Project: Proposed Network Rail Essex Level Crossing Reduction Order

Our reference: 367516 TN 41

Subject: Visibility on Station Hill, Bures and Chilternditch Lane

Figure 3: Plan view of visibility splays on Station Hill and view looking westbound from the east side of the railway

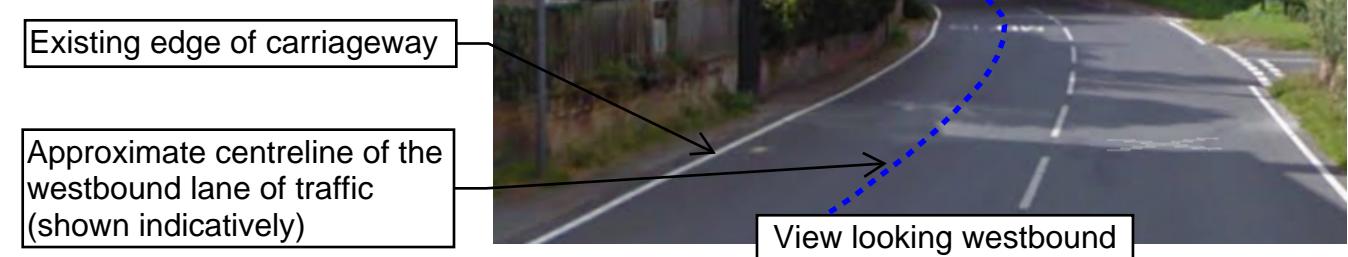
- 3.2.6** The forward visibility plan at Appendix B of the Ramblers Visibility Technical Note has been reviewed against the visibility splay calculated by Mott MacDonald.

- 3.2.7** Forward visibility is checked by measuring between points on a curve along the centreline of the inner lane of traffic.
- 3.2.8** There is a difference in the forward visibility splays / envelopes calculated by Mott MacDonald and the Ramblers' Association due to the different approach taken to establish the centreline of the westbound lane of traffic.

- 3.2.9** The Mott MacDonald assessment has taken into account the edgeline and centreline of Station Hill in order to assess the driving line for westbound vehicles in the westbound lane along which the visibility should be checked (the centre of the westbound lane). The edgeline can be seen in the photograph inset in Figure 3 below and it has been provided to delineate the edge of carriageway in this location in line with the guidance set out at Paragraph 4.31 in Chapter 5 of the Traffic Signs Manual (see Appendix A).

- 3.2.10** The Ramblers' Association assessment appears to use the boundary wall features to the east of and through the railway bridge, and the kerbline into the side road on the west side of the bridge as the edge of carriageway. These features do not represent the edge of carriageway for Station Hill. In addition, the offset used by the Ramblers' Association does not appear to represent the centre of the westbound lane. This approach is not considered to represent a realistic drivers' eye point for drivers travelling along the main carriageway for assessment of forward visibility in accordance with Section 7.8.1 of MfS. It should also be noted that the drive line into the side road, Parsonage Hill, does not need to be considered.

- 3.2.11** The Mott MacDonald assessment has concluded that a minimum forward visibility of 34.6m is achievable for drivers travelling westbound along Station Hill on approach to the vicinity in which existing users of the level crossing would need to cross Station Hill (see Figure 3) when checked in accordance with MfS and MfS2.

- 3.2.13** Based on the above, the visibility assessment undertaken by Mott MacDonald during the design development using Computer-aided Design (CAD) modelling concluded that a vehicle travelling along the street has appropriate SSD in advance of a pedestrian crossing Station Hill, and hence, the diversion route is considered suitable.
